ADDENDUM 2
RE: Project Bidding Documents for:

DONALD GRAHAM ELEMENTARY SCHOOL
SHADE STRUCTURE ADDITION &
PLAYGROUND IMPROVEMENTS
LAKE ELSINORE UNIFIED SCHOOL DISTRICT

DSA Appl. No. 04-125609
DSA File No. 33-15

tBP Project No. 24002.00

SITE DEMOLITION PLAN

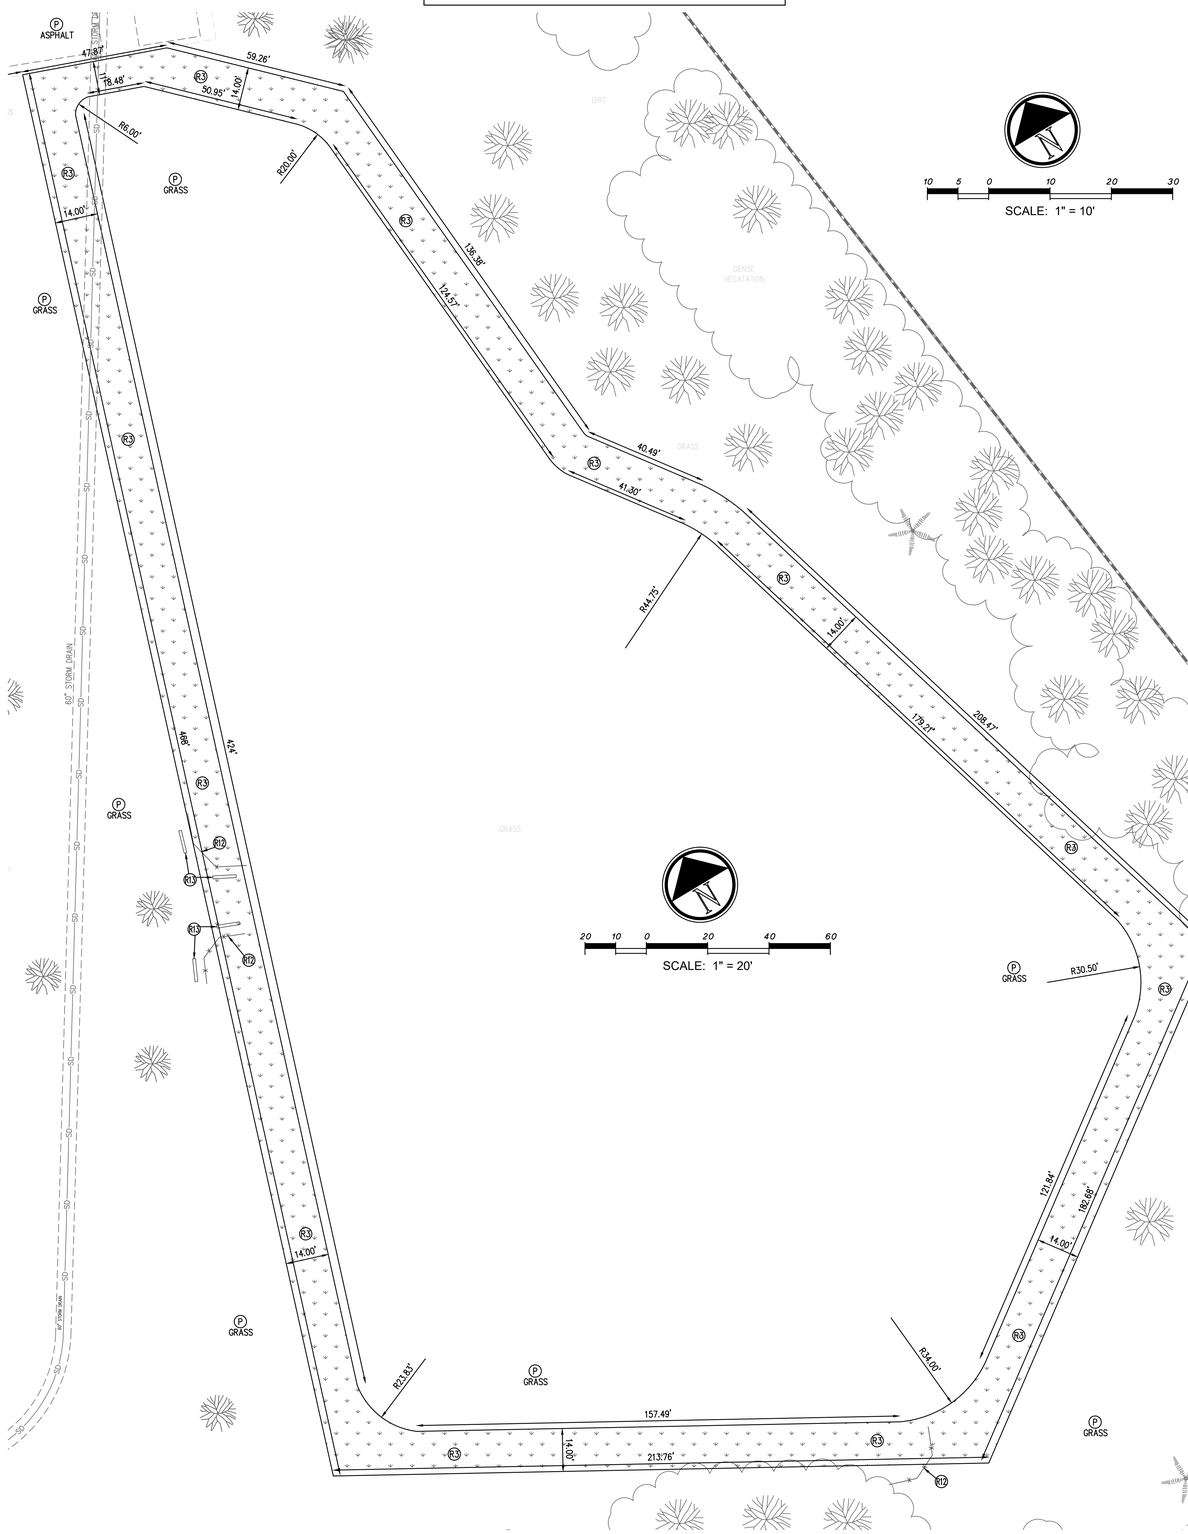
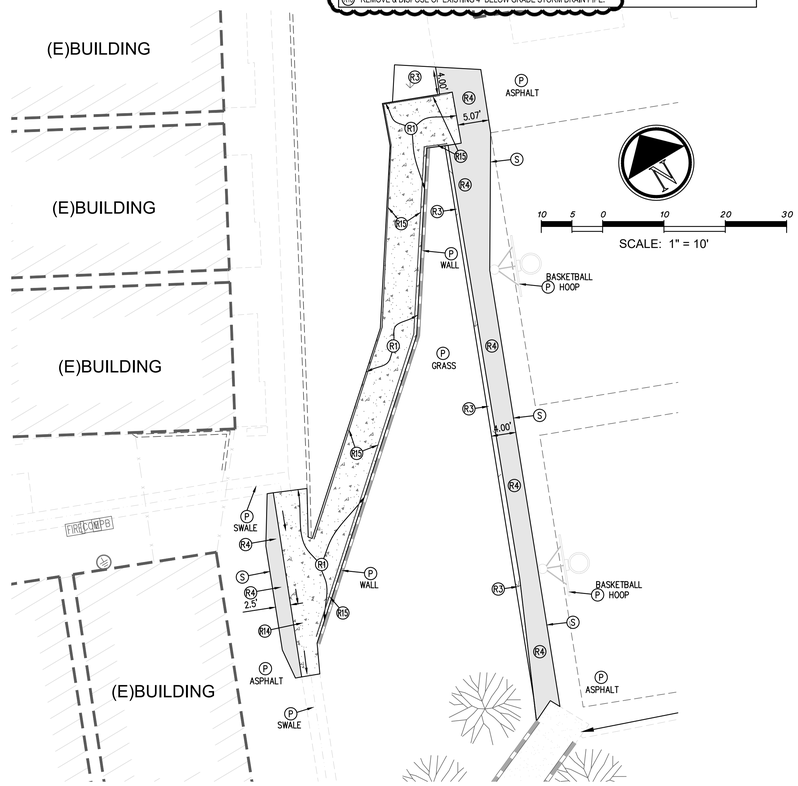
1. Sheet C1.01 SITE DEMOLITION PLAN (Refer to revised ***C1.01***)
    a. Revised to relocate existing 4” storm drain line to clear new footings

C2.01

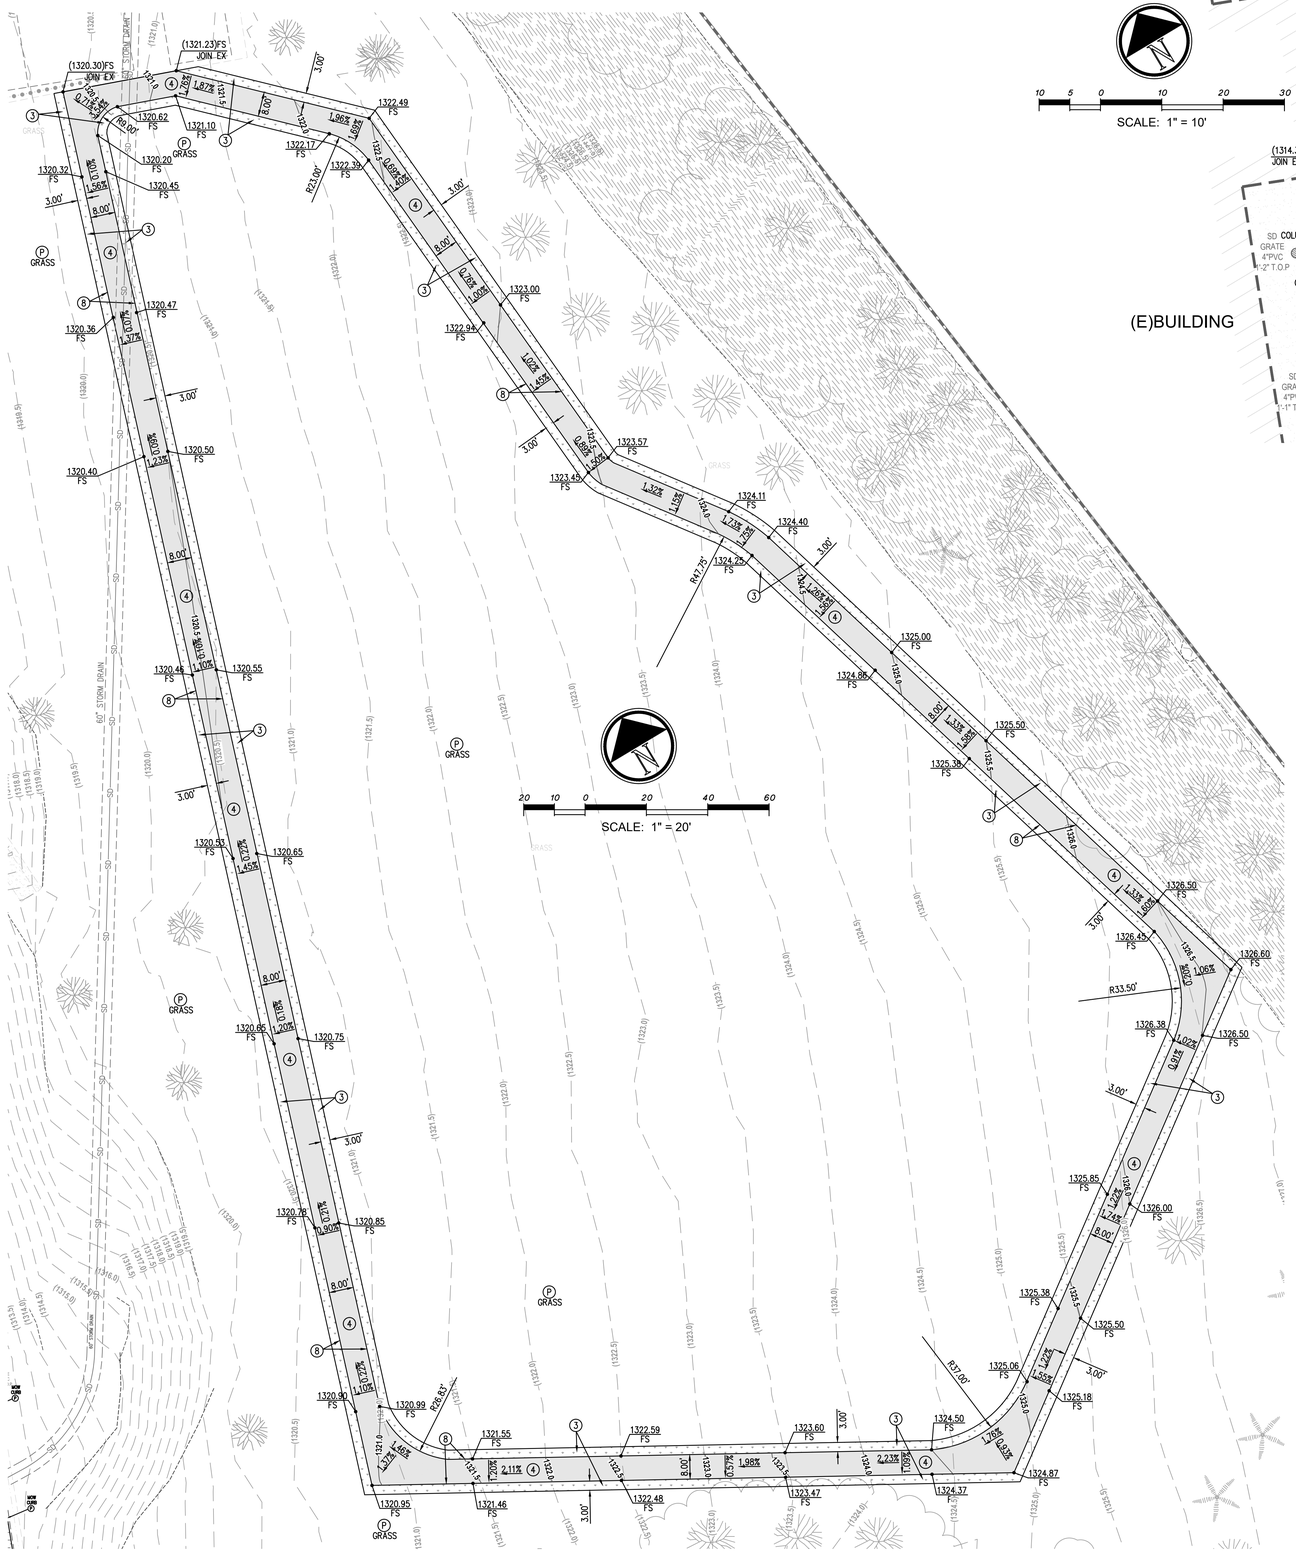
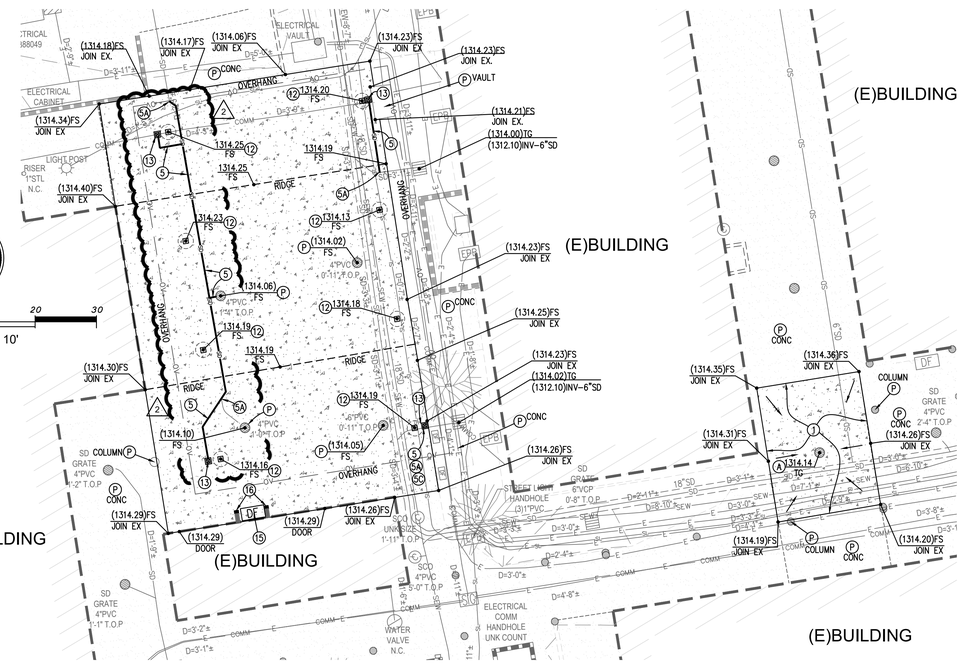
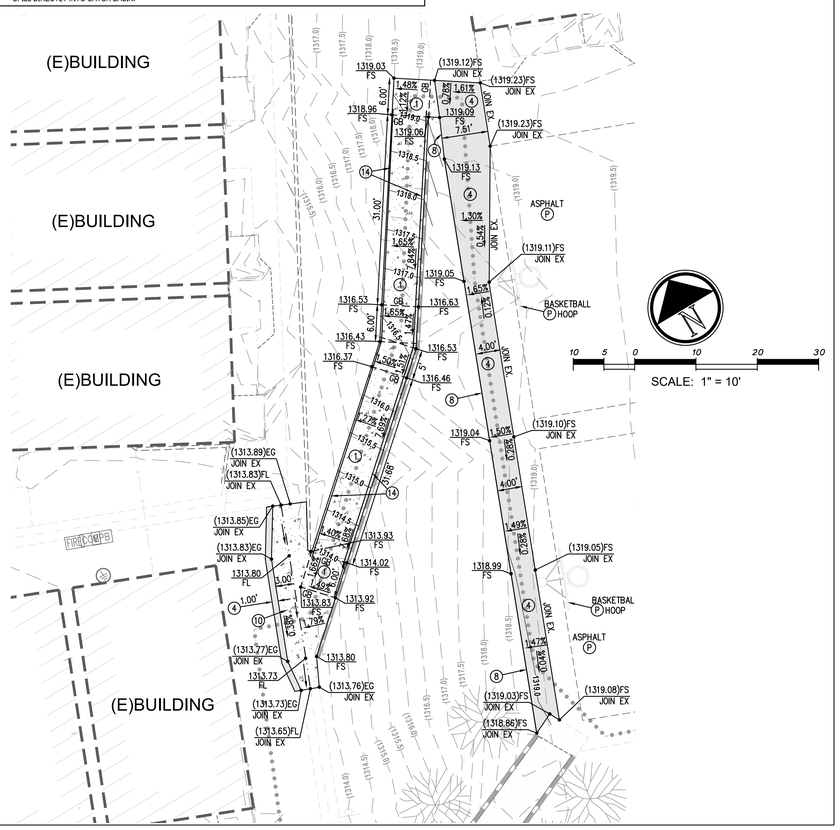
2. Sheet C2.01 GRADING PLAN (Refer to revised ***C2.01***)
    b. Revised to relocate existing 4" storm drain line to clear new footings

The proposed shade structure area between (E) Buildings ADMIN and E is shown with a hatch pattern (PROPOSED CONCRETE PAVEMENT), but no keynote is provided.

Please confirm whether new concrete pavement is required throughout the hatched area.

Yes this area is to receive new concrete pavement, as shown in the hatch legend on C2.01, construction note 1 applies to this area.
Ron Canedy, VP, FPL 11/3/2026

DECORATIVE GATE W/ PANIC HARDWARE — SCALE: 3/8" = 1'-0" — 1

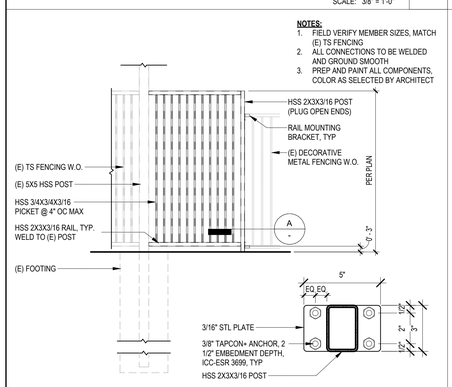
4. Sheet 2.01 SITE DETAILS (Refer to revised ***2.01***)
    a. Revised 1/2.01 to provide detail reference to added detail 13/2.01
    b. Revised 11/2.01 to provide detail reference to added detail 13/2.01 Sim
    c. Added detail 13/2.01 to clarify condition at panic hardware (section view)
    d. Revised 17/2.01 to provide bottom rail lieu of tension wire

SCALE: 1" = 1'-0" | 5

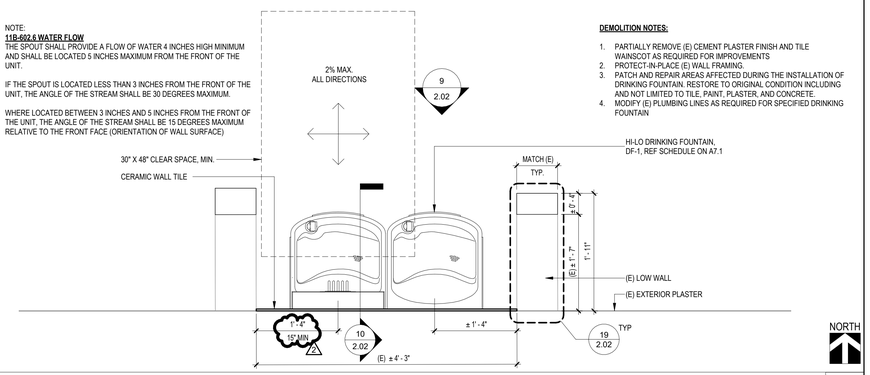
5. Sheet 2.02 SITE DETAILS (Refer to revised ***2.02***)
    d. Revised 5/2.02 to clarify 15" MIN from accessible drinking fountain centerline to face of adjacent wing wall.
    e. Revised 9 & 10/2.02 to clarify accessible drinking fountain height to be installed at +2'-10" AFF (Bubbler Height).
    f. Revised 13 & 14/2.02 to clarify native soil under Rubber Playground Surfacing shall be compacted to 90%.
    g. Revised 19/2.02 to clarify curb extension attachment to existing curb.
